Submittal Review Response

Project Name: Hilo WWTP Rehabilitation and Replacement Project Phase 1
Submittal No.: 05500-001.1
Date: 9/30/2025

Client: County of Hawai'i **Carollo Project No.:** 203975
Contractor: Nan, Inc.
Submittal Name: Grating Support in Grit Basin - Shop Drawing Resubmittal
Reviewed By: Marissa Kurniawan, Hipom Caleb Che

ALUMINUM GRATING SUPPORT FRAME PLAN
REF.DWG.=02-S-01-105

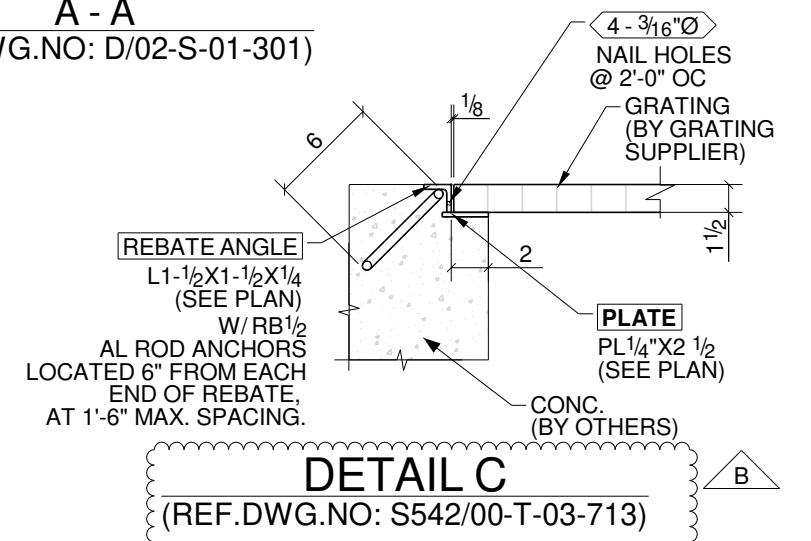
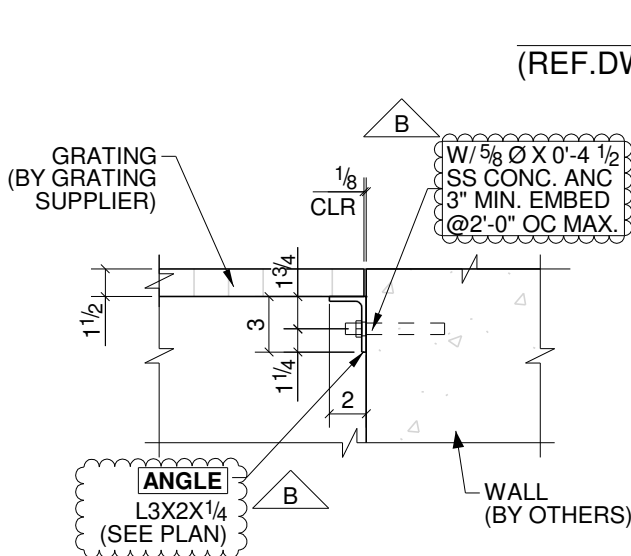
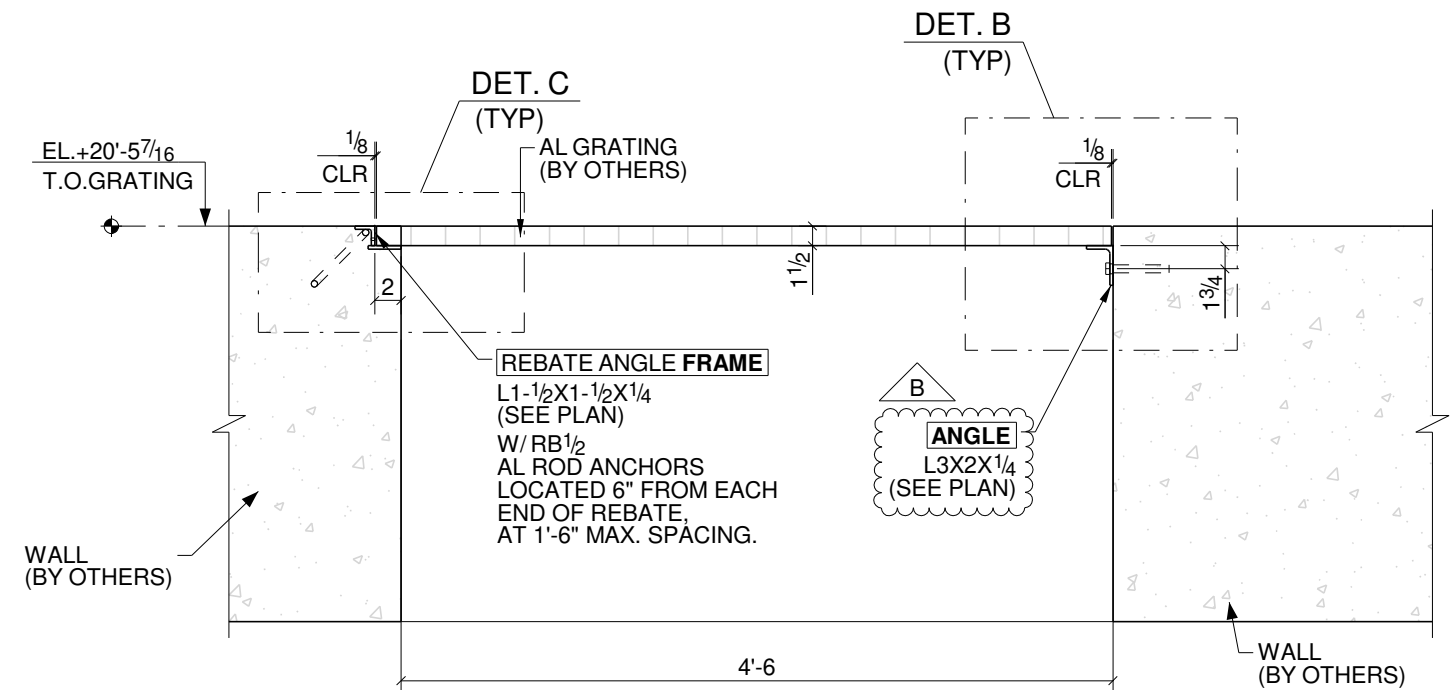
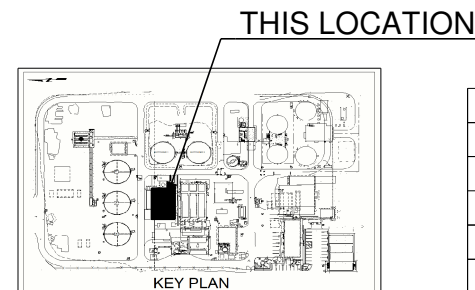
- 8. All clouded sizes/dimensions shown are confirmed. Contractor to field verify and coordinate all final dimensions.
- 9. Submittal page 13 calls out cross section B-B, but B-B is not shown anywhere in the submittal.

1~ANGLE~02-1110

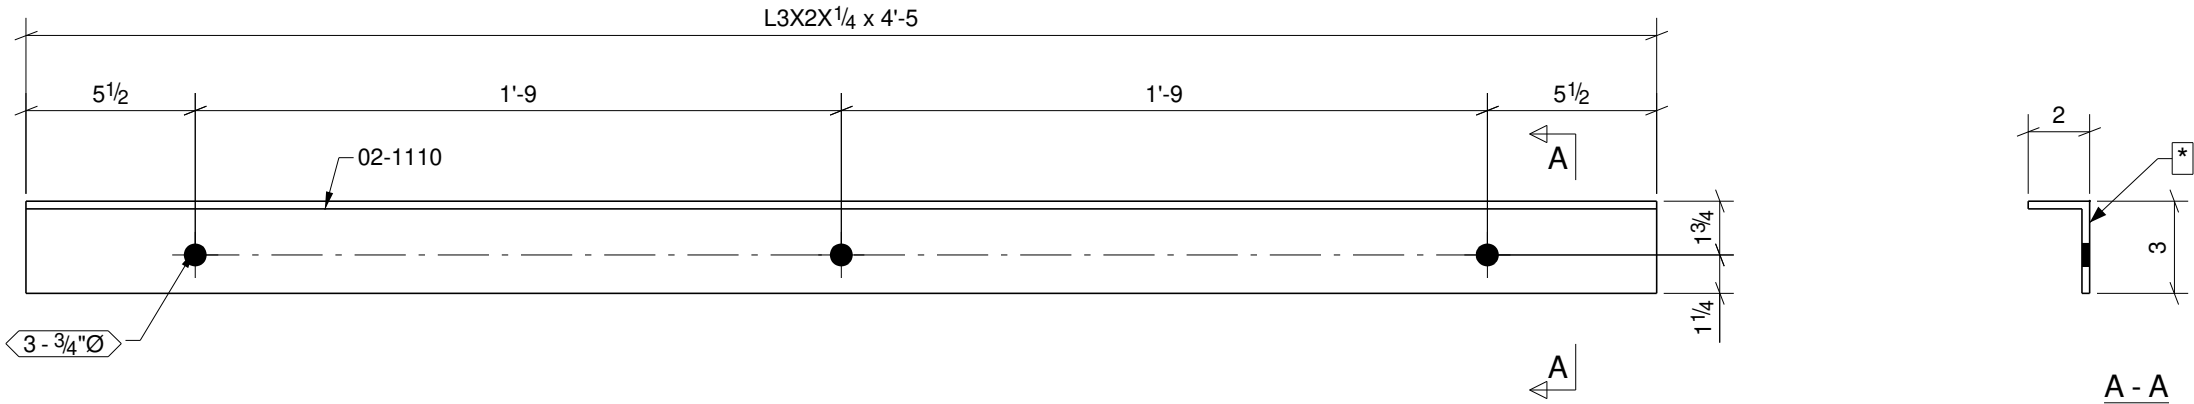
- Contractor's Response: Incorporated in Page 13 and Page 14.
 - Engineer's Response: Acknowledged. Comment Closed.
- Do not use bent plates for aluminum ledger support. Bending of aluminum plate may lead to cracking and breaking.

Provide AL L3x2x1/4 per Detail S542/Typ for the ledger support.

- a. Contractor's Response: Incorporated in Page 12.
 - b. Engineer's Response: Acknowledged. Comment Closed.
6. Ledger angle concrete anchors shall be Type 316 SST per S542/TYP.
- a. Contractor's Response: Incorporated in Page 12.
 - b. Engineer's Response:
 - 1) Shop drawings show SST but not the grade of the anchor. Confirm that ledger angle concrete anchors are Type 316.
 - 2) Do not interrupt reinforcing bars for installation of post-installed anchors.
7. Provide welding details of rebate per S542/TYP.
- a. Contractor's Response: Incorporated in Page 12 and Page 13.
 - b. Engineer's Response: Acknowledged. Comment Closed.
